DRAWN & DRAFTED BY	LIU YOU SEN	TOLERANCES		ANGLE:	TITLE:		
		0<L≤4 ±0.1 4<L≤16 ±0.2 16<L≤63 ±0.3	pin pitch ±0.2	±1°	BOBBIN RM-14		
CHECKED & APPROVED BY				UNIT:	BOBBIN MATERIAL:	UL REC.	
				MM	PHENOLIC PM9630	UL 94V-0	
 PIN SHINE INDUSTRIAL CO.,LTD. TEL:886-2-22990545 FAX:886-2-22990546				ORIGIN:	PIN MATERIAL:	PIN TENSION LOAD:	
				SZ	CP WIRE	1.5kg MIN	
					DATE:	DRAWING NO.	REV.
					JUN.05 '2003	P-1409-1	6

VIEW B

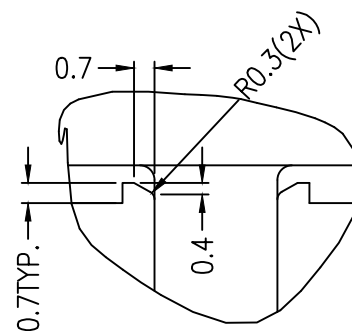
REV.	REVISIONS	REC.	REV.	REVISIONS	REC.
1	形狀變更		4	腳長由3.7±0.2改為3.0±0.2	
2	材質由FR530改為PM9630;		5	VIEW B增加0.3mm膠位,且倒0.3圓角.	
3	底部和頂部擋牆的里面斜度取消, 擋牆尺寸由0.8改為1.0		6	VIEW B R0.3刪除,DETAIL A 結構設變.
